ADDENDUM NO. 2

Life Sciences Collaboration
 1910 N. Antelope Valley
 Parkway
 Lincoln, Nebraska
 TCEP No.: 716-002-12
 Davis Design.: 12-0077
 BVH No.: L12018.unl
 November 27, 2013

FIRST FLOOR REFLECTED CEILING PLAN - AREA A
SCALE: 1/8\"/>

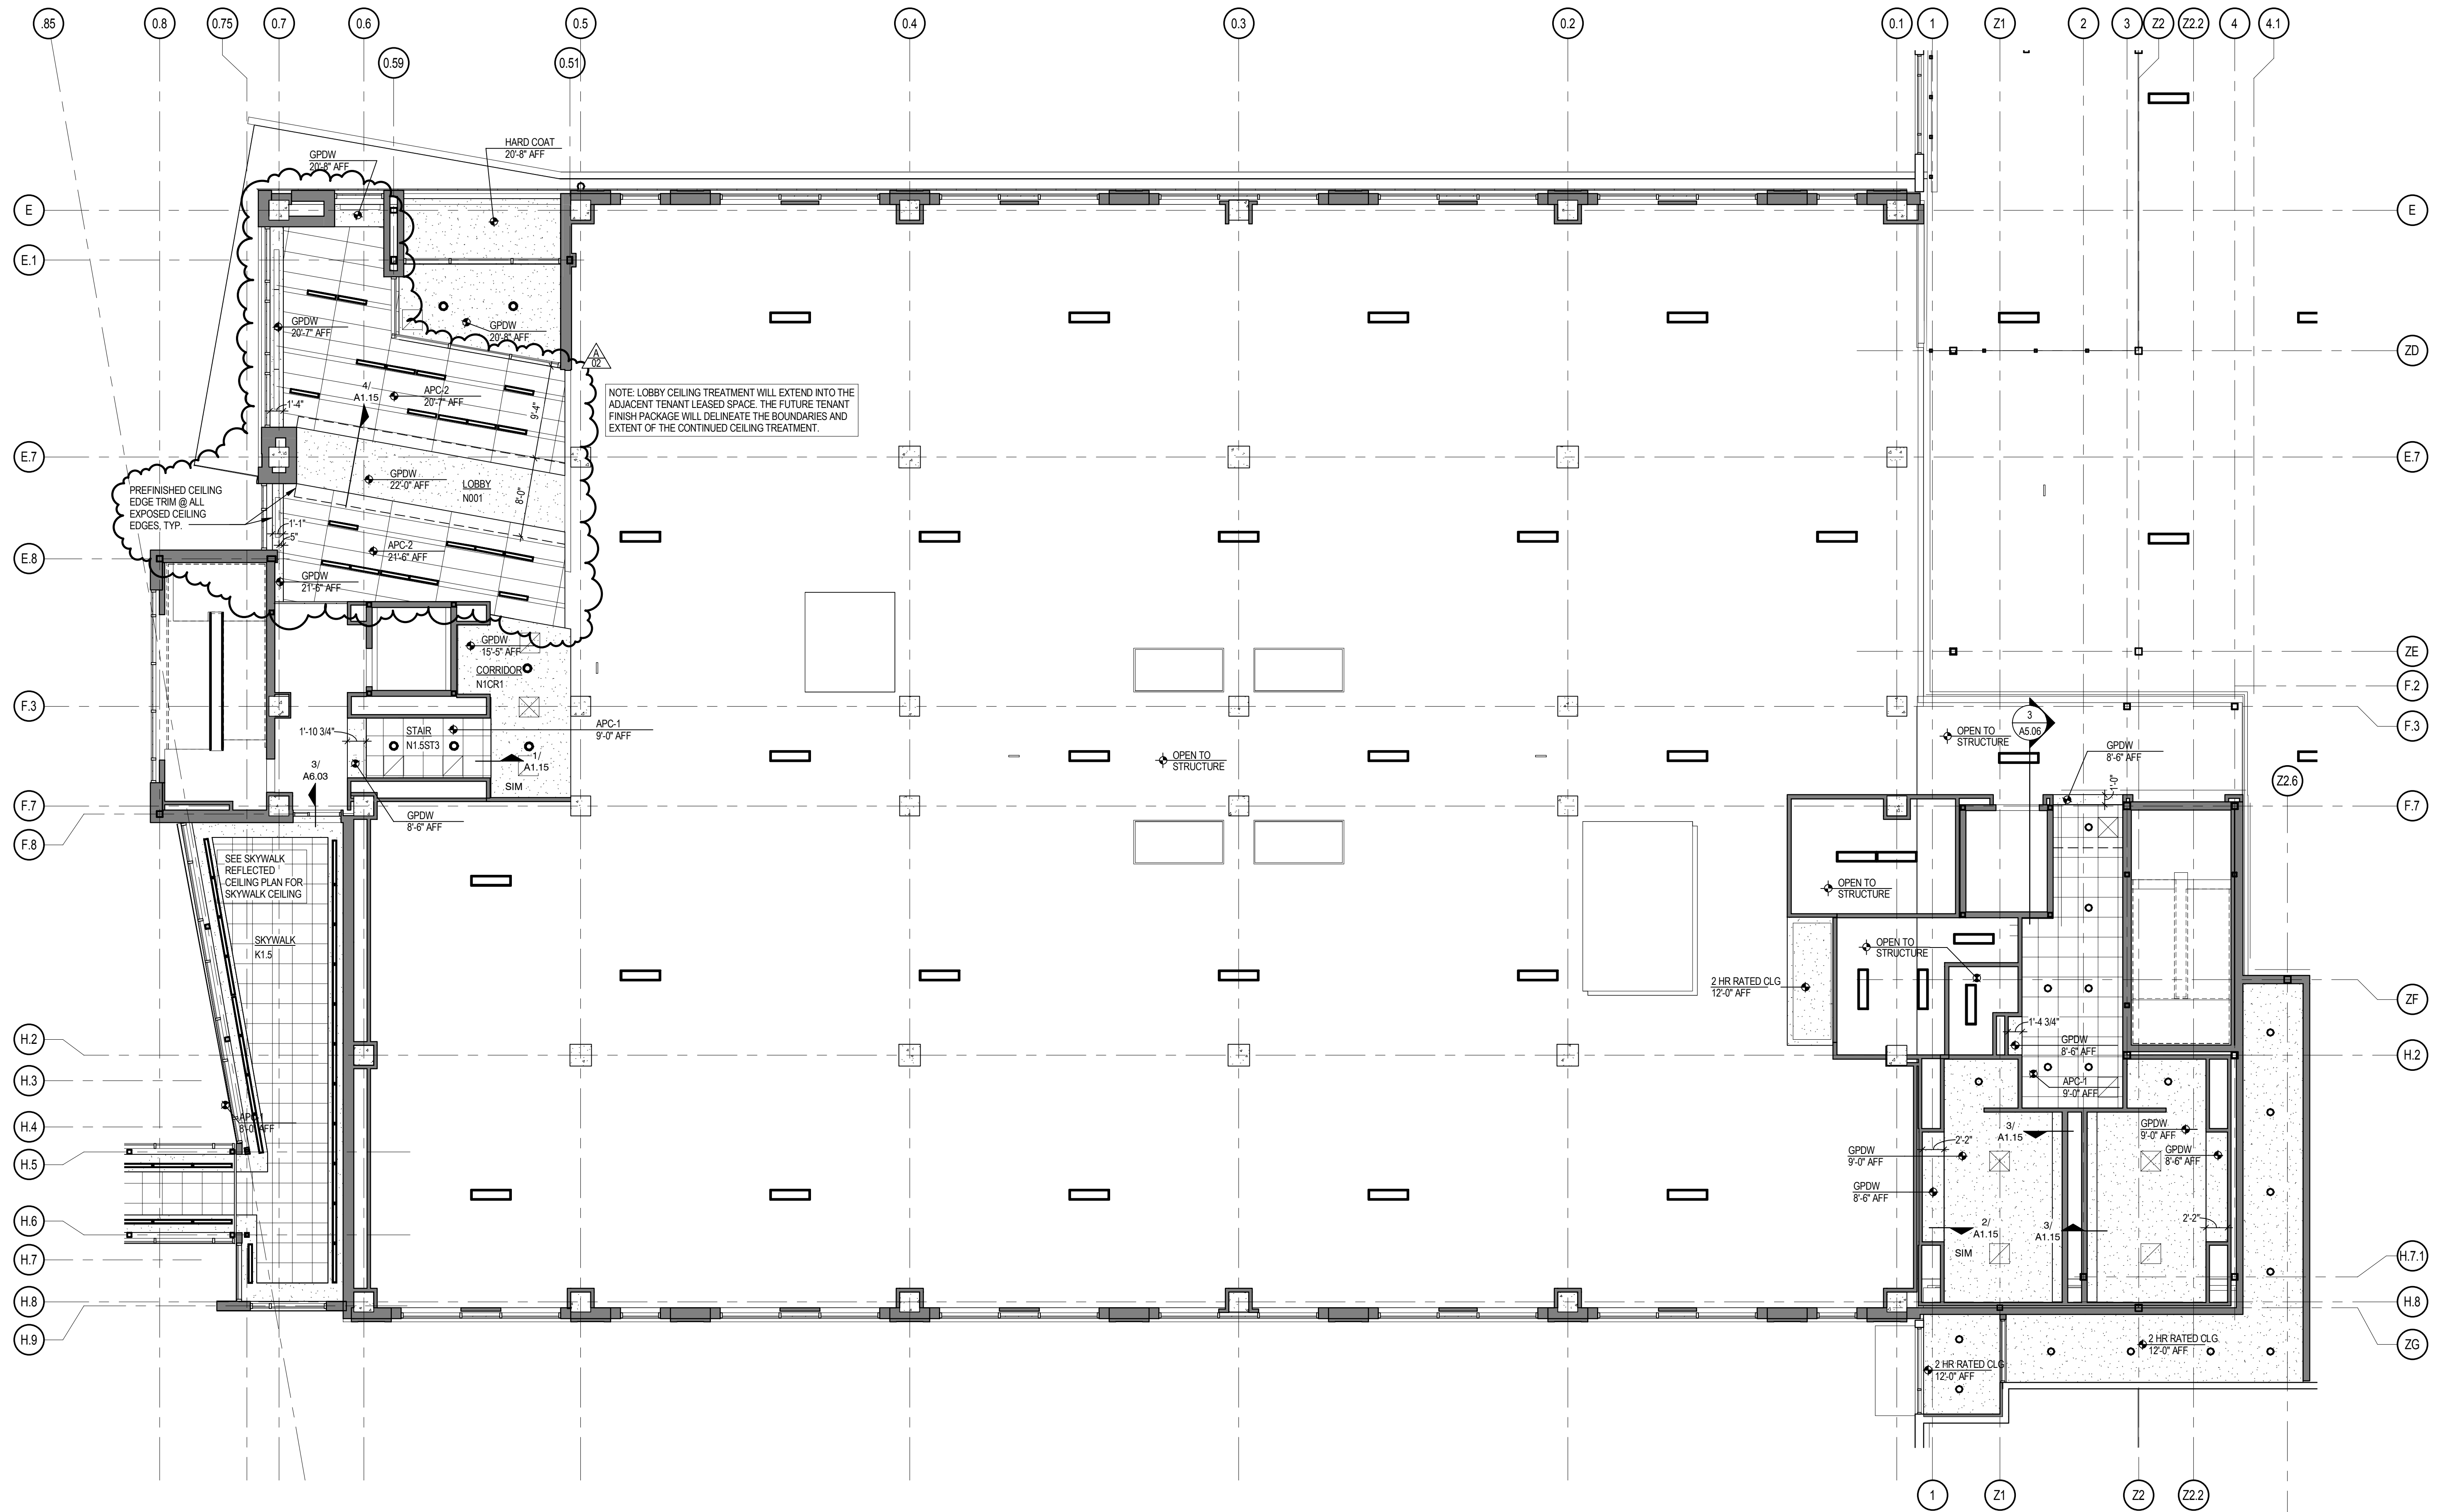
Item 2-40: Sheet A1.15 – First Floor Reflected Ceiling Plan – Area A

See revised sheet for updated ceiling in Lobby and light cove detail.

Mechanical Penthouse
Floor Plan - Area A

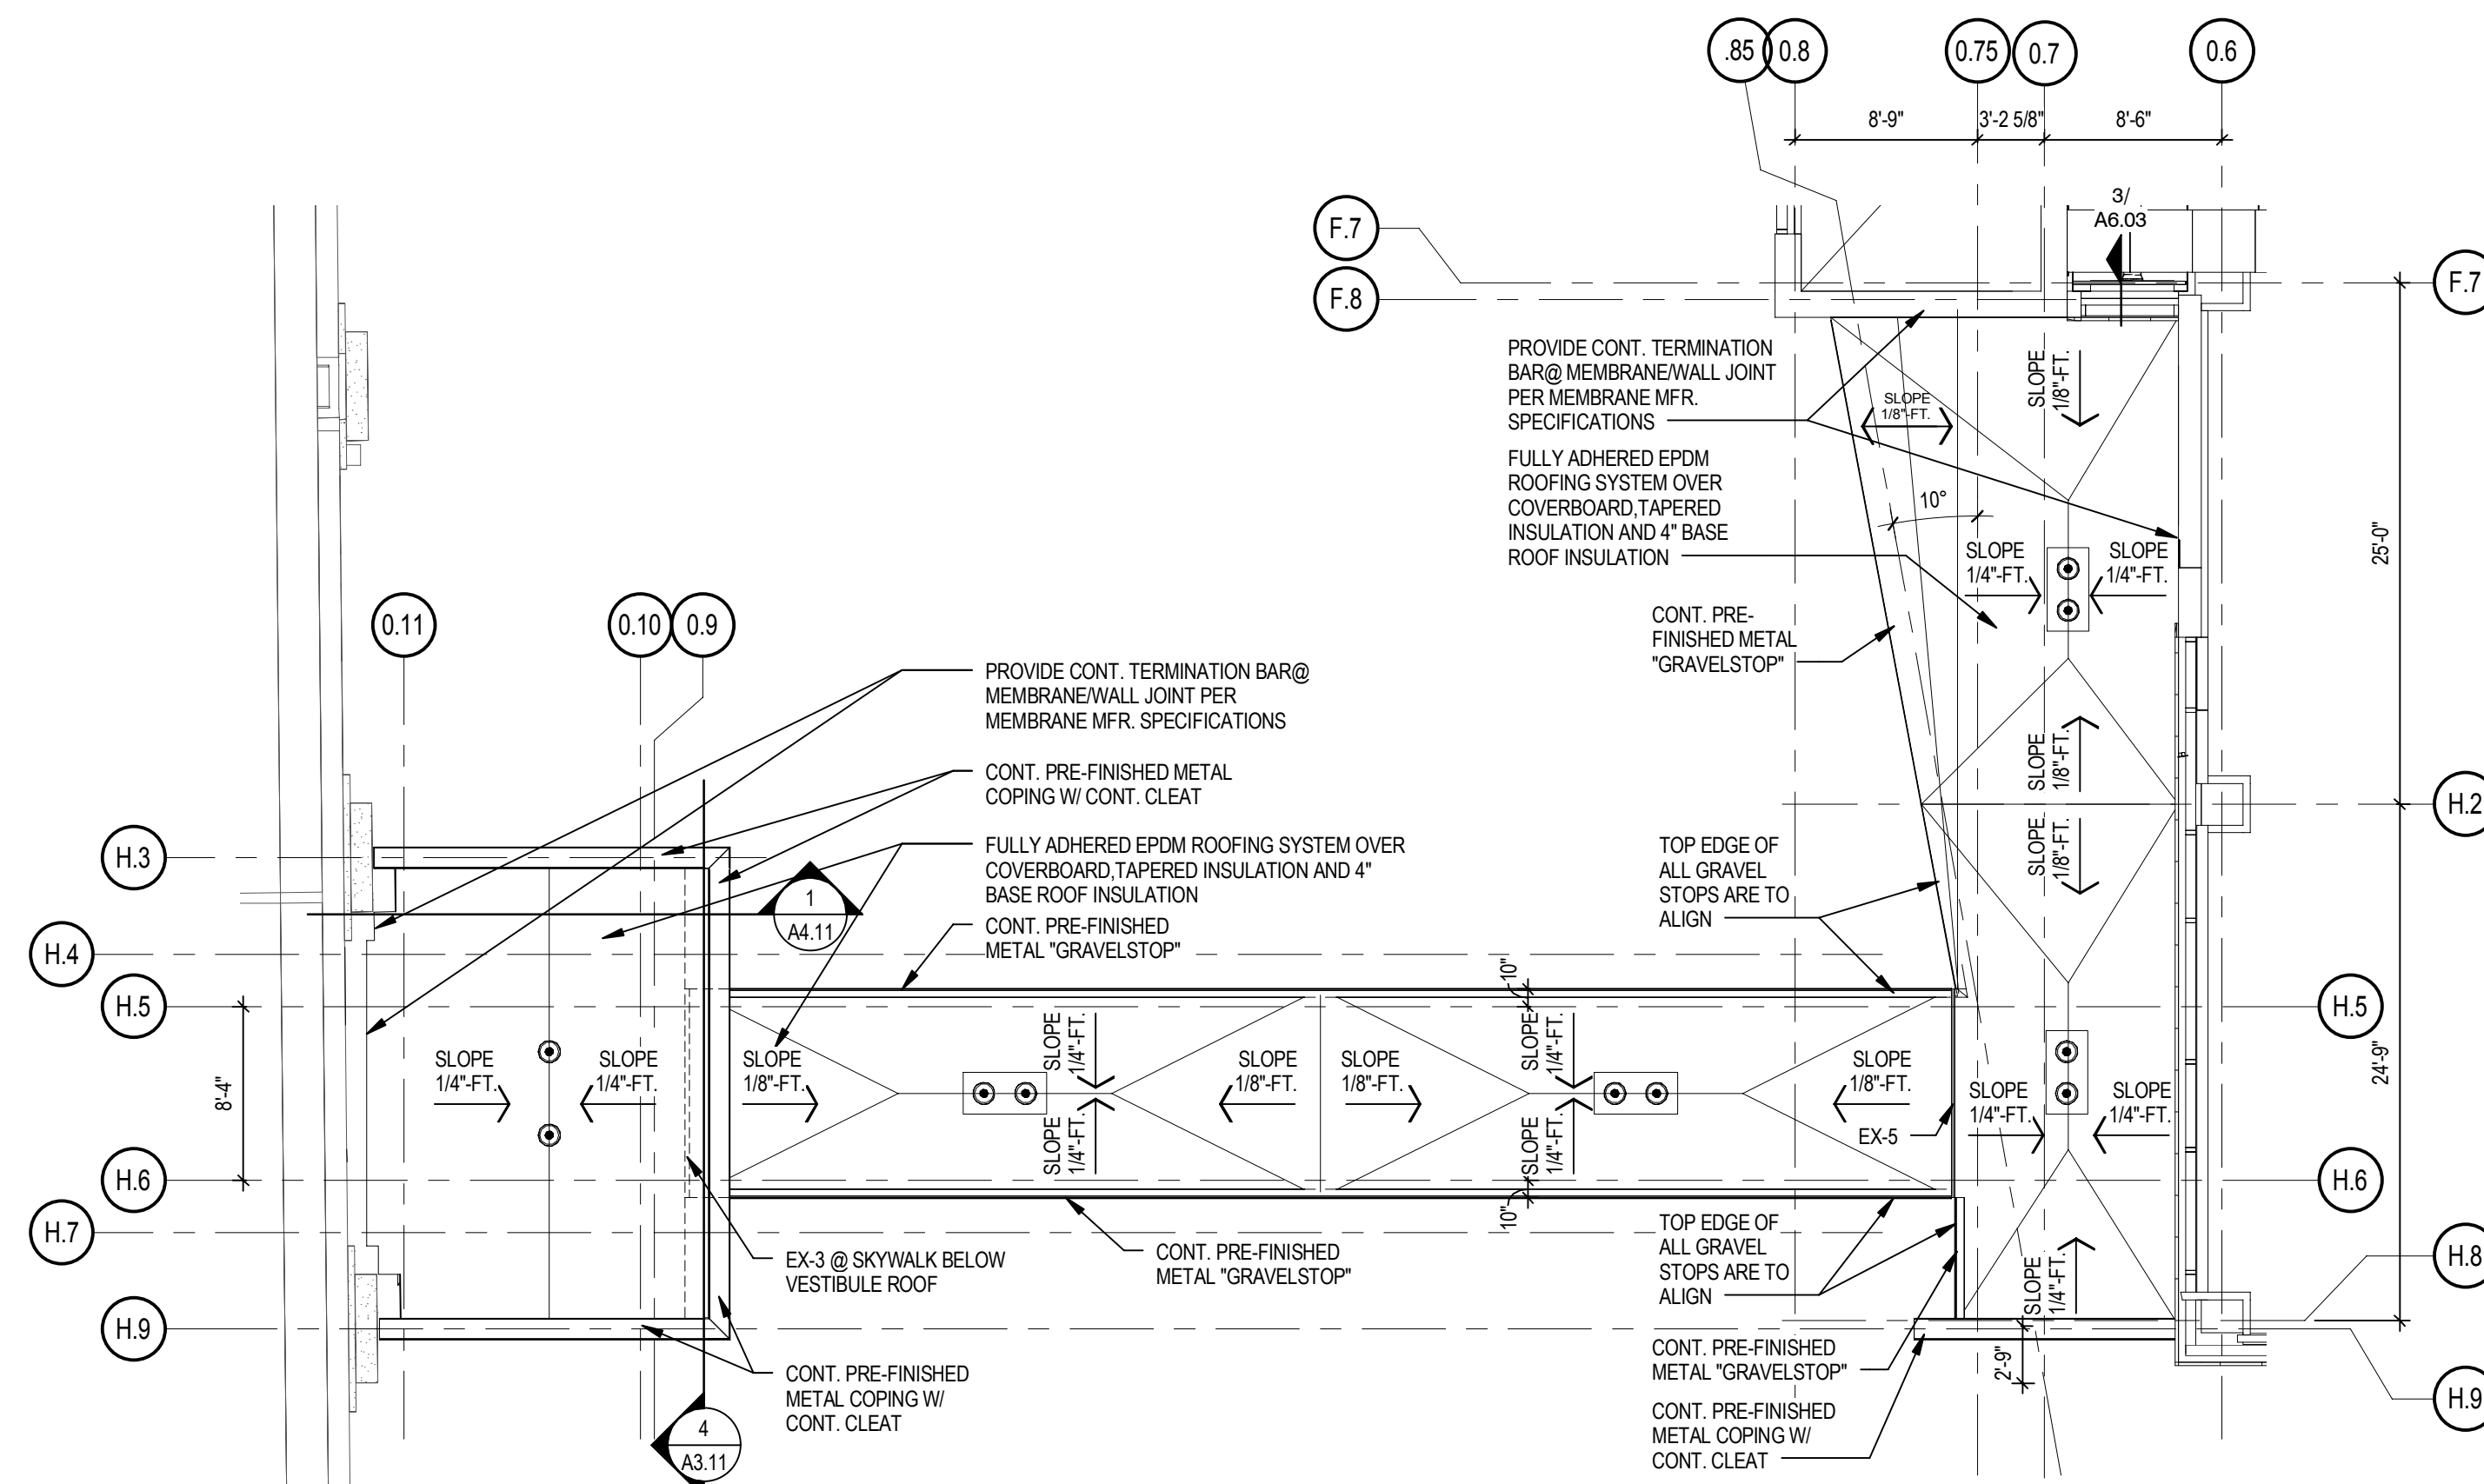
Item 2-42: Sheet A1.51 – Mechanical Penthouse Floor Plan – Area A

See revised sheet with added notes for equipment pad and steel step.
